**URBAN DESIGN REVIEW BOARD
STAFF REPORT
Meeting Date: July 18, 2025**

The applicant is requesting conceptual design approval from the Urban Design Review Board (UDRB) for the proposed development of a two-building data center complex located on a 10-acre, heavily wooded, vacant parcel within the Gillem District (GZ).

BUILDING 1 ELEVATIONS

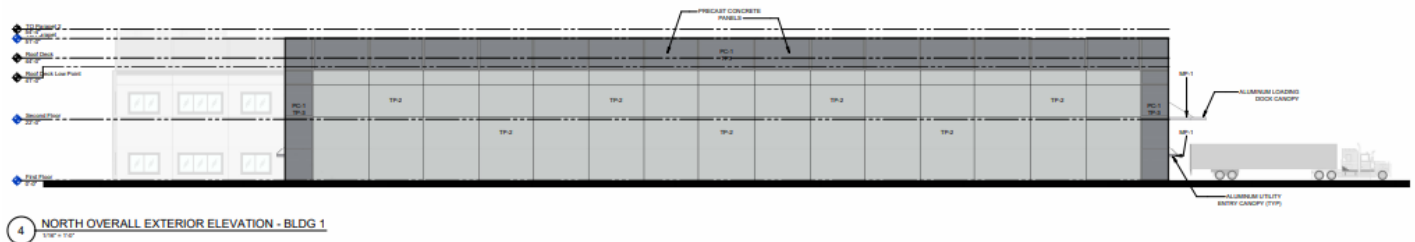
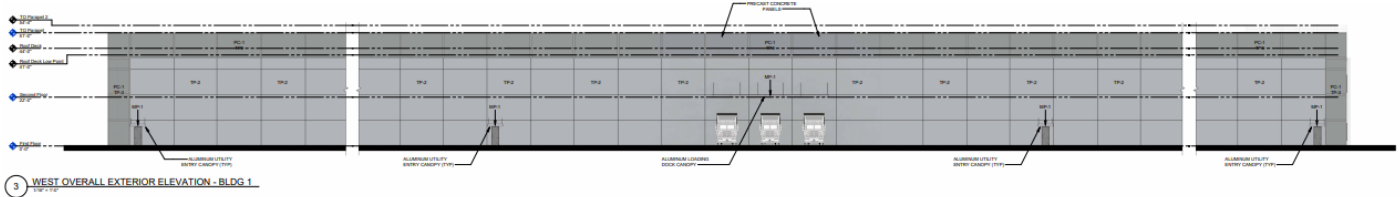
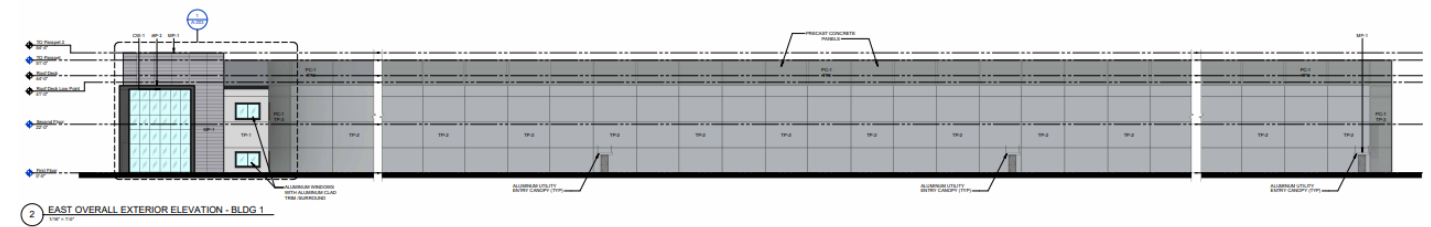
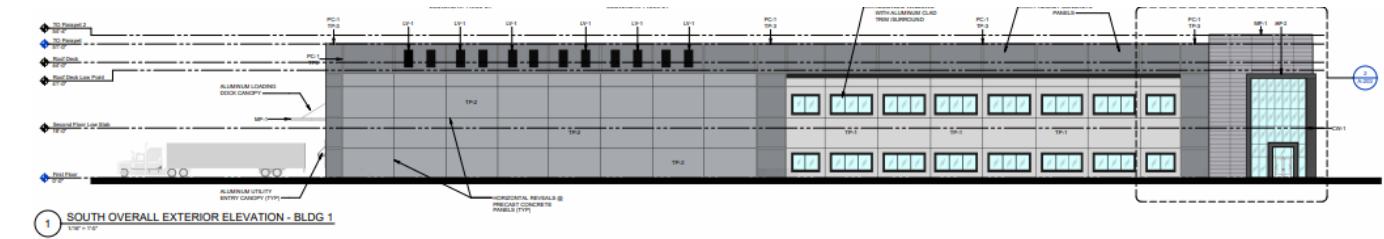
1. The side of the building facing the residential properties shall feature an enhanced façade incorporating thoughtful design elements and a mix of materials to improve visual interest and better integrate with the neighboring homes, given its close proximity.

2. The exterior walls must be soundproofed using a double-wall system, resilient clips, and a Green Glue noise control system.
3. All existing trees along the north and west perimeters of the property must be preserved.
